**SITE PLAN REVIEW SHEET
ENVIRONMENTAL VARIANCE REQUEST ONLY**

CASE: SP-2019-0170C

PROJECT NAME: Allegro Parmer

Project Name: Allegro Parmer, SP-2019-0170C
 Ordinance Standard: Watershed Protection Ordinance
 Variance Request: LDC 25-8-261 to allow development within a critical water quality zone

B-07

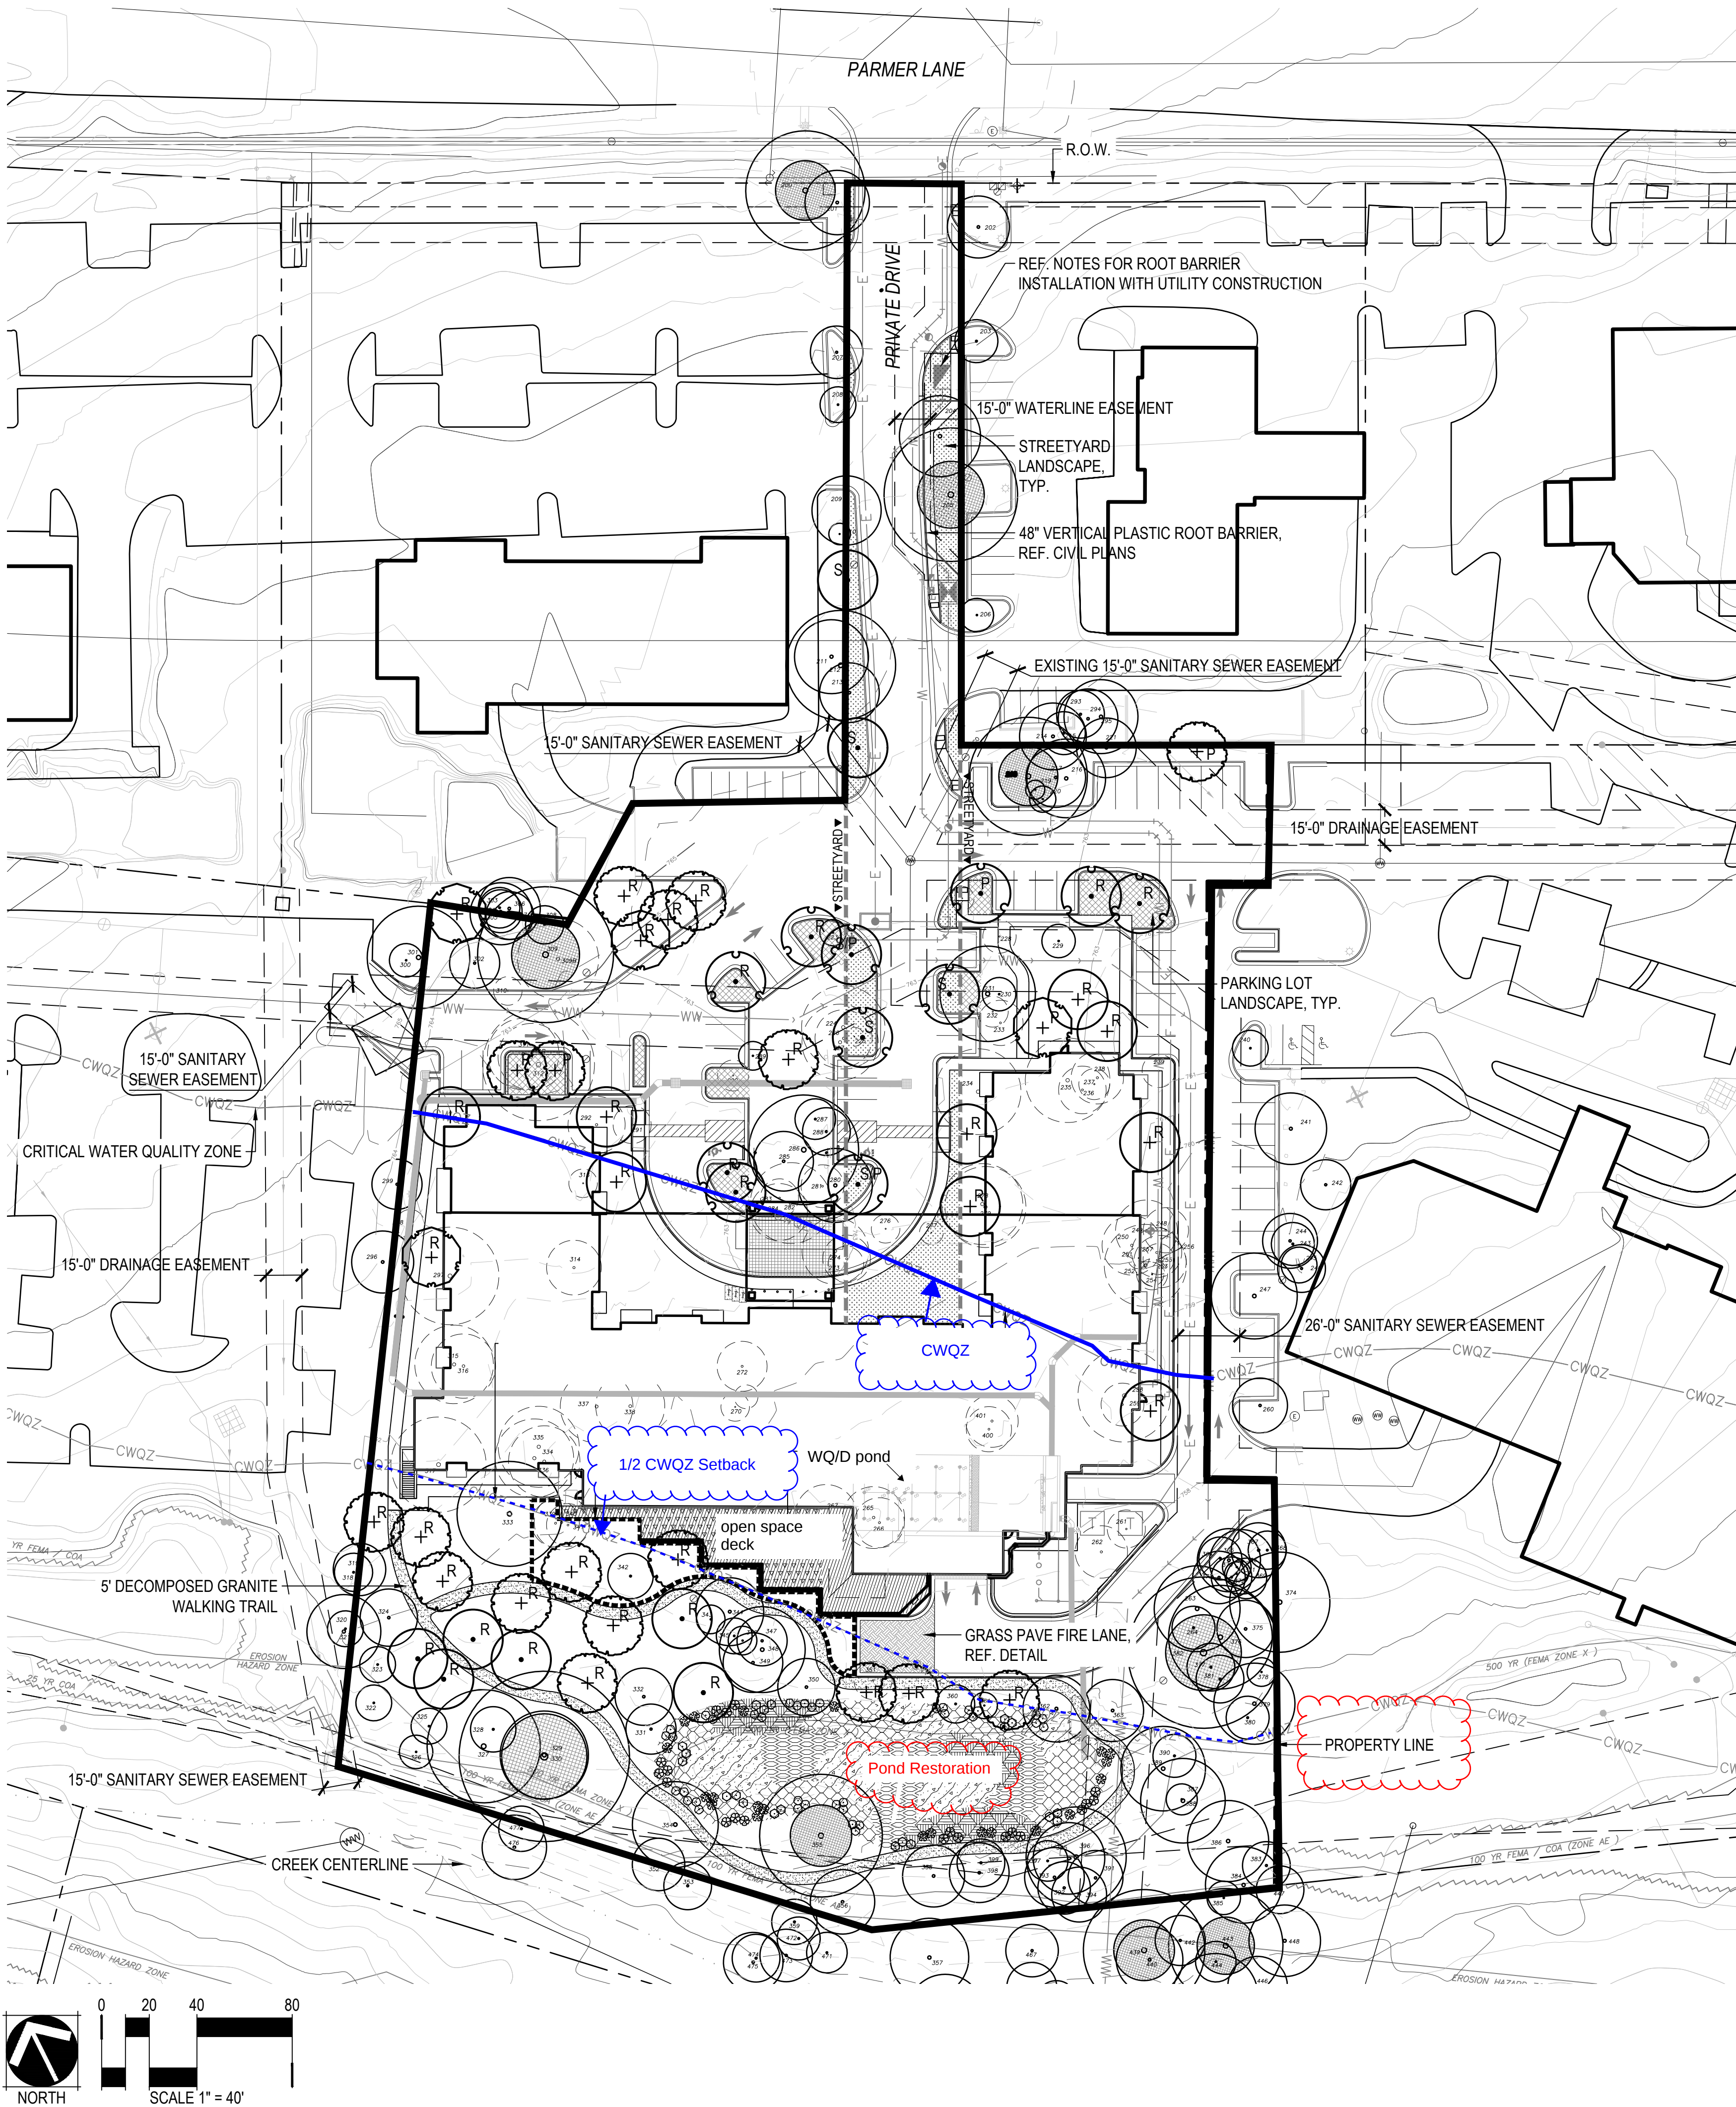
Half CWQZ

WQ/D
pond
